**Product Change Notification / RMES-26BJAP489**

CCB 4646 Initial Notice: Qualification of MMT as an additional assembly site for various Atmel products available in 8L UDFN (2x3x0.6mm) package.

**PCN #: RMES-26BJAP489**

**CCB 4646**  
**Pre and Post Change Summary**  
**PCN #: RMES-26BJAP489**

# LEAD FRAME COMPARISON

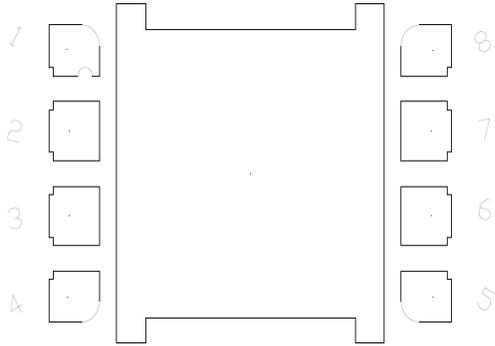
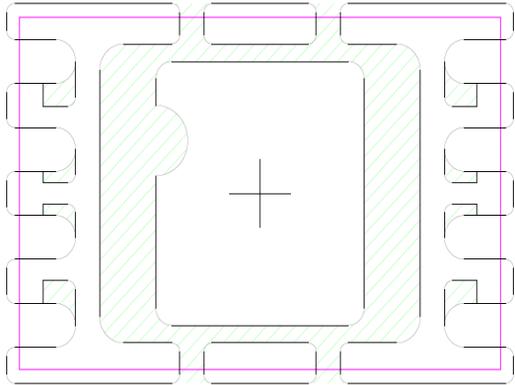
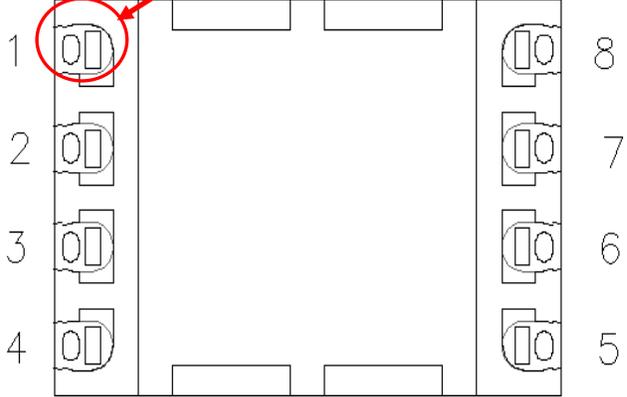
ASE		ATP 7		MMT	
 <p>Diagram of ASE lead frame showing a central chip area with leads on all four sides. Leads are numbered 1 through 8, starting from the top-left corner and moving clockwise.</p>		 <p>Diagram of ATP 7 lead frame showing a central chip area with leads on all four sides. A green hatched area indicates the lead lock holes. A pink border outlines the lead frame.</p>		<p>Lead Lock (Locking Holes)</p>  <p>Diagram of MMT lead frame showing a central chip area with leads on all four sides. Leads are numbered 1 through 8, starting from the top-left corner and moving clockwise. A red circle highlights the lead lock hole at lead 1, with a red arrow pointing to it.</p>	
Lead Frame Material	C7025	Lead Frame Material	C7025	Lead Frame Material	EFTEC-64T
Lead Lock	Yes	Lead Lock	Yes	Lead Lock (Locking Hole)	Yes
Paddle size	73 x 67 mils	Paddle size	79 x 67 mils	Paddle size	79 x 67 mils

**NOTE:** Mold compound material fills the [lead lock hole](#), which provides improved protection against moisture penetration along the edge of the leads (pins) of the package.
